Power Steering Reservoir Hose Leak

Models Covered	Serial Number
All Sterndrive ECT 8.2 Liter Engines	2A041665–2A180547

53564

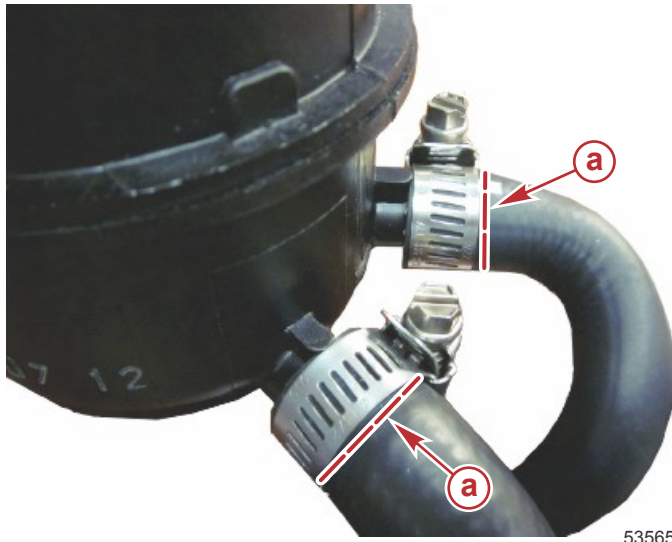
Mercury MerCruiser has observed power steering fluid leaking from the return hose at the power steering reservoir on some engines. This is due to mispositioned or loose hose clamps.

Inspect the power steering reservoir hoses during predelivery inspection (PDI) or when servicing 8.2 ECT sterndrive engines within the above serial number range. The hose clamp position must be forward of the reservoir's barbed fitting, and the clamp must be torqued.

Description	Nm	lb-in.	lb-ft
Hose clamp	4	35	-
